Application for Works Approval Amendment

Works Approval Number	W6767/2022/1
Works Approval Holder	Hamersley HMS Pty Ltd
ACN	115 004 129
File Number	DER2022/000660
Premises	<p>Hope Downs 4 Iron Ore Mine – BOO Crushing and Screening Plant</p> <p>Legal description –</p> <p>Part of ML 282SA, NEWMAN WA 6753</p> <p>As defined by the Premises map in Schedule 1 and the coordinates in Schedule 2 of the Revised Works Approval.</p>
Date of Report	18 October 2024
Proposed Decision	Revised works approval granted

Figure 1: BOO Crushing and Screening Plant and Infrastructure Layout Map

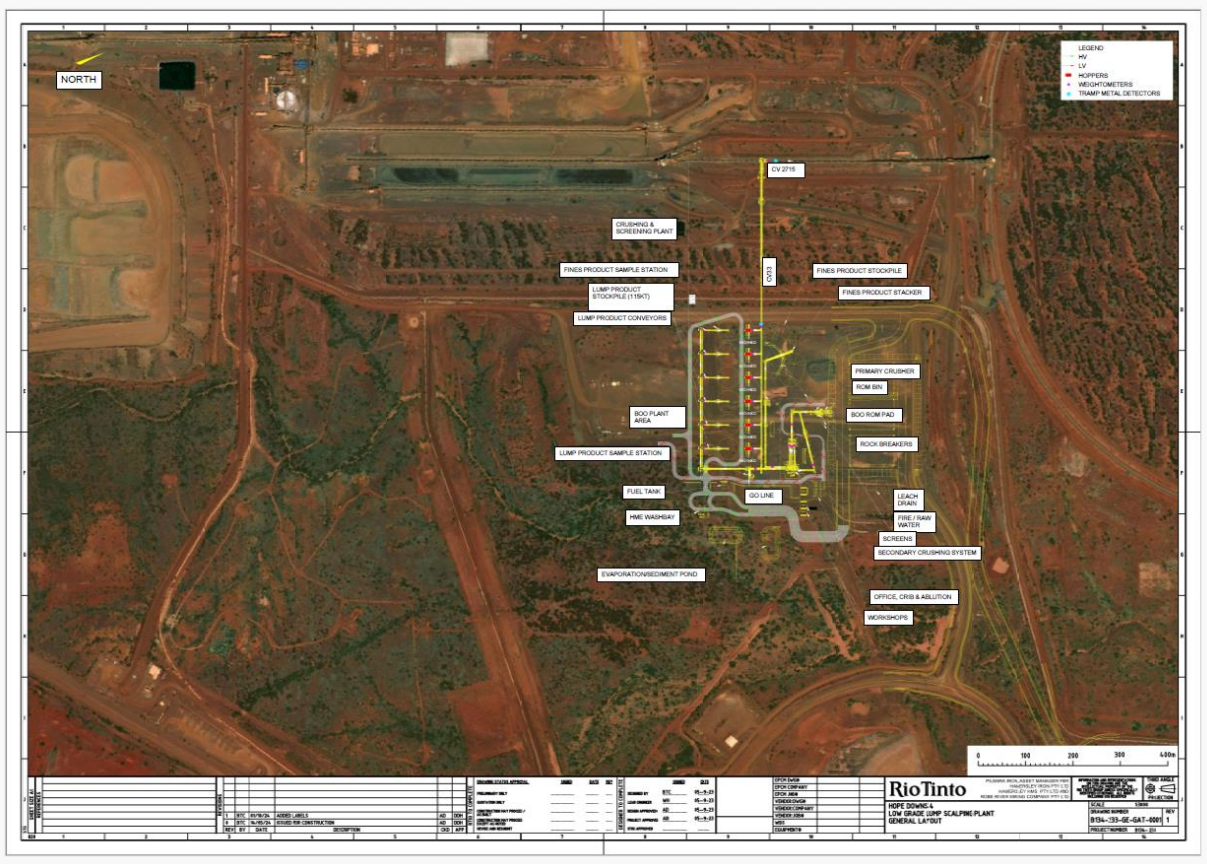
<p>Figure 1: BOO Crushing and Screening Plant and Infrastructure Layout Map</p> <p>Section 2.3.2 of the amendment report: Revised schedule for construction, commissioning and time limited operations</p> <p>DWER requested the applicant advise of the duration of the commissioning timeframe as three months was stated in the supporting documentation, however the works approval stipulates 60 days.</p>	The Works Approval Holder requested that the duration of the environmental commissioning timeframe be amended to from two months to three months.	<p>Figure 1 of the amendment report has been updated with the updated figure provided by the applicant that includes all infrastructure associated to part V activities and additional labelling of infrastructure.</p> <p>The wording of Section 2.3.2 of the amendment report has been updated to allow for a three-month environmental commissioning duration. The Application summary (Section 2.2 of the amendment report) has been updated to include this additional proposed amendment to the works approval.</p>
